N4696D-02

# Modification Recommended Service Note

## N4696D Electronic Calibration Module (ECal)

Serial Numbers: MY57450000-MY99999999

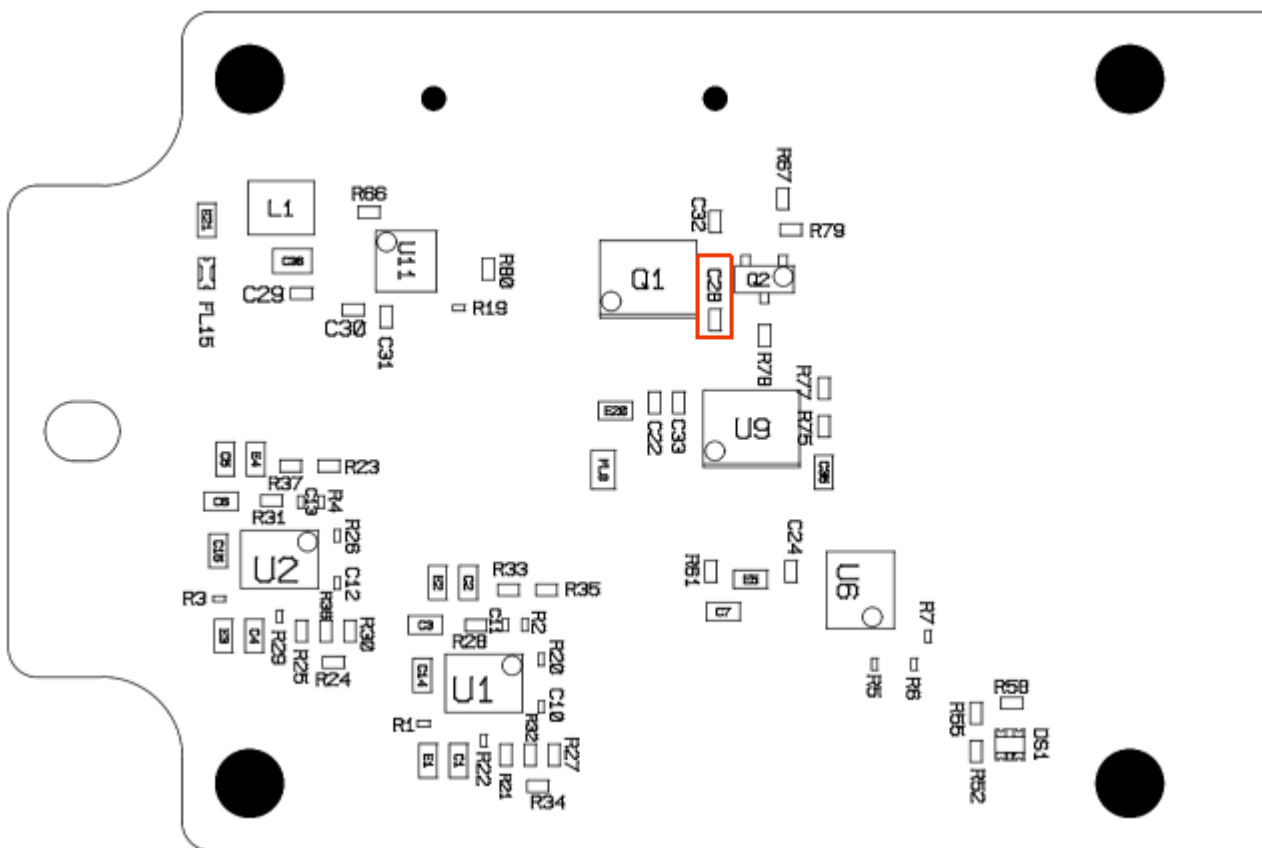
The heater circuit in the N469xD ECal modules was initially designed with a dampening capacitor. It was found in a small number of ECal modules that a resonance can develop in this circuit after the modules is warmed up. This resonance can cause an RF tone between 140 MHz and 150 MHz to be injected onto the signal path.

The dampening capacitor was eliminated in all ECal modules with serial prefix MY5941 and above.

Open the ECal module and remove the N4690-63004 printed circuit board. On this board, locate the C28 capacitor indicated here:

If this capacitor has been removed, no further action is required. Reassemble the ECal module.

If this capacitor exists on this board, this capacitor should be carefully unsoldered and removed, or the N4690-63004 printed circuit assembly should be replaced. Once this is done, reassemble the ECal module.
